SERVICE TECHNICAL INFORMATION

ONE POINT REPAIR

UTSUNOMIYA, AUGUST 15, 1998
 REF. NO.: SI-98-019
 CUSTOMER RELATIONS & SERVICE DIV.

MODELS : XR-H3MD
 SUBJECT : MD does not operate

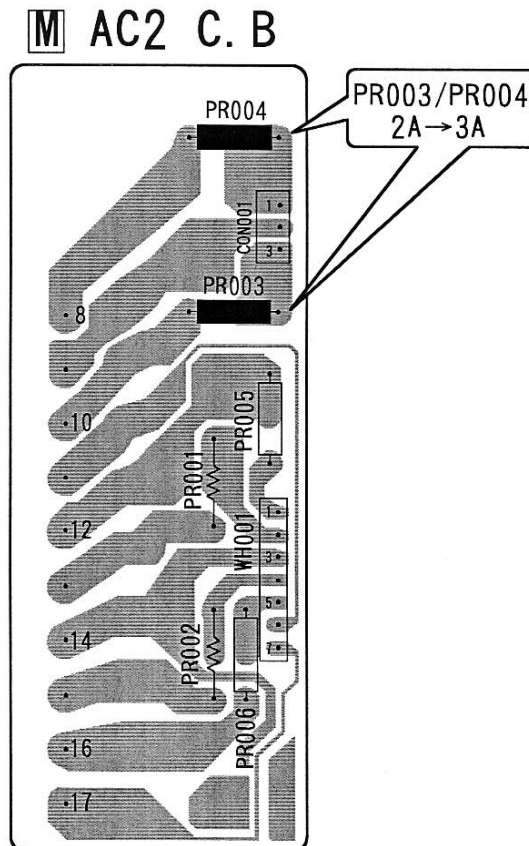
DESCRIPTION : In the model mentioned above, the MD will not operate when PR003 and PR004 are broken. Upon parts replacement, change PR003 and PR004 to the following parts.
 Parts replacement : PR003 / PR004 2A → 3A

Ref.	Part name	Part No.	Remarks
PR003/PR004	PROTECTOR, 3A 491 60V	87-A90-093-080
